**Flood Control Project Maintenance
Levee Inspections**

Fall 2015 Levee Maintenance Deficiency Summary Report

Reclamation District No. 1500 Sutter Basin

Photo 1 of 3 : UCIP_FA_2015_3224.jpg

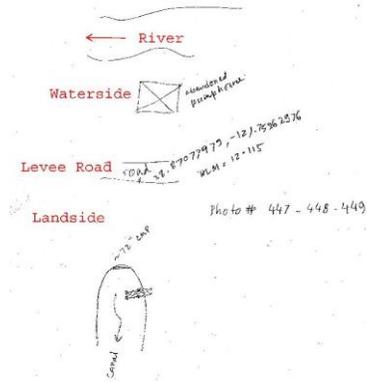
LM Start	12.00	Rating **	M	Issue No.	2573
LM End	12.00	Issue Type +	En	Location *	WS
Category	Supplemental		GPS Latitude/Longitude		
			Start	End	
Item	DWR UCIP Field Study		38.870780 °	38.870780 °	
			-121.752630 °	-121.752630 °	
DWR ID					
Action/Comments					
Inspector Comments: FS_ID:41744 DS_ID:20008 EP_NO: N/A FS_HLM: 12.115 Repair Type: Non-Urgent Crossing Status: Indicator Found UCIP Comments: An abandoned pump house on waterside and a 72-inch corrugated metal pipe on landside. The pipe discharges into irrigation ditch (canal). Water was flowing during the field visit. Needs to verify from LMA whether this pipe is through the levee or not. FIELD_STRUCT_DESC: 1 of 2: Two 4 foot and 3.5 foot concrete culverts through levee, 17 feet below the crown, pump on WS. FS Date: 01/10/2014

Inspector Comments: FS_ID:41744
 DS_ID:20008
 EP_NO: N/A
 FS_HLM: 12.115
 Repair Type: Non-Urgent
 Crossing Status: Indicator Found
 UCIP Comments: An abandoned pump house on waterside and a 72-inch corrugated metal pipe on landside. The pipe discharges into irrigation ditch (canal). Water was flowing during the field visit. Needs to verify from LMA whether this pipe is through the levee or not.
 FIELD_STRUCT_DESC: 1 of 2: Two 4 foot and 3.5 foot concrete culverts through levee, 17 feet below the crown, pump on WS.
 FS Date: 01/10/2014

Photo 3 of 3 : UCIP_FA_2015_3395.jpg

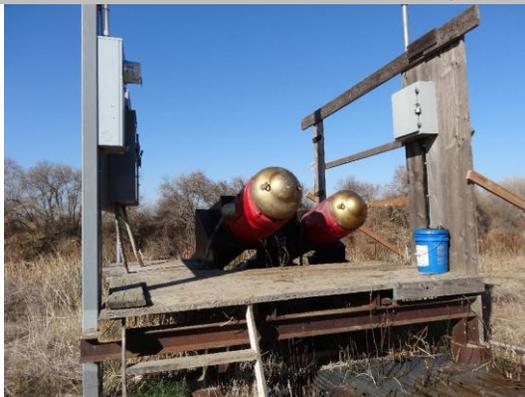
LM Start	29.91	Rating **	U	Issue No.	2594 (cont)
LM End	29.91	Issue Type +	En	Location *	WS
Category	Supplemental			GPS Latitude/Longitude	
				Start	End
Item	DWR UCIP Field Study			38.993006 °	38.993006 °
				-121.796025 °	-121.796025 °
DWR ID					
Action/Comments					
Inspector Comments: FS_ID:42930 DS_ID:20084 EP_NO: 10054 FS_HLM: 30.28 Repair Type: Urgent Crossing Status: Found UCIP Comments: Levee slope erosion due to leakage from siphon breaker. Water leaking from pipe near distribution box on landside levee toe. Overhead powerline. FIELD_STRUCT_DESC: 1 of 2: 20-inch steel irrigation pipe through levee, 5.0 feet below crown. Siphon breaker in 24-inch CM riser on landward slope. Another 16-inch steel irrigation pipe through levee, 5.0 feet below crown. Siphon breaker in 24-inch CM riser on landward shoulder. Slant pumps in CM pump house mounted on steel pile structure on the berm. A 4 foot by 7 foot concrete inspection box for Hersey-Sparling water meter on berm in front of pump house. Flap gates in 9.7 foot by 10.6 foot O.D. concrete distribution box at landward toe. (ABO No. 10054 - Larner) O&M Manual Sac 128, March 1960. FS Date: 01/15/2014

WS view: slant pumps and control boxes on steel platform at levee berm.
